Access Compliance Report

Public Rights-of-Way

Intersection ID: 26586	Main Street: ARBORHILL_RD	Cross Street: WINTHROP_RIDGE_RD	Location: W
ADA ID: 55FDAF285DC4	Ramp Type: Perp	Initial Pass/Fail: Fail	Overall Compliance: No
		Severity Score: 12.5

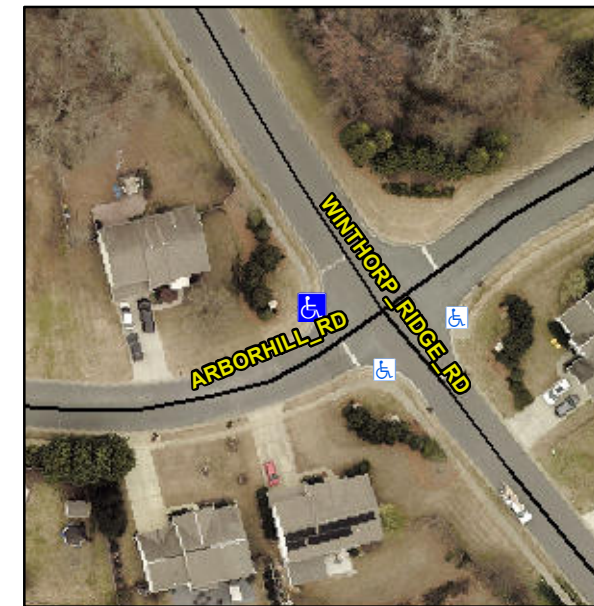
Not Found, R304.5.3

Compliance	Description	Data	Compliance	Description	Data
N/A	Ramp Length (in)	48.0	Yes	Ramp Slope (%)	6.3
Yes	Ramp Width (in)	48.0	No	Ramp XSlope (%)	6.1
N/A	Flare Type LT	N/A	N/A	Flare Type RT	N/A
N/A	Flare Slope LT (%)	N/A	N/A	Flare Slope RT (%)	N/A
N/A	Flare Traversable LT?	N/A	N/A	Flare Traversable RT?	N/A
N/A	Landing Length (in)	N/A	N/A	DWS Provided?	N/A
N/A	Landing Width (in)	N/A	N/A	DWS Contrast?	N/A
N/A	Landing Slope (%)	N/A	N/A	DWS Length (in)	N/A
N/A	Landing X Slope (%)	N/A	N/A	DWS Full Width?	N/A
N/A	Landing Curb? (Y/N)	N/A	N/A	DWS Offset (in)	N/A
N/A	Shared Landing?	N/A			
N/A	Gutter Ponding?	N/A	N/A	Gutter Slope (%)	N/A
N/A	Gutter Lip Ht (in)	N/A	N/A	Gutter X Slope (%)	N/A
N/A	Painted X Walk1?	No	N/A	Painted X Walk2?	N/A
	X Walk 1 Direction	To SE		X Walk 2 Direction	N/A
N/A	X Walk 1 Width (in)	N/A	N/A	X Walk 2 Width (in)	N/A
	X Walk 1 Slope (%)	3.0		X Walk 2 Slope (%)	N/A
	X Walk 1 X Slope (%)	0.7		X Walk 2 X Slope (%)	N/A

Remove & Replace Entire Ramp.
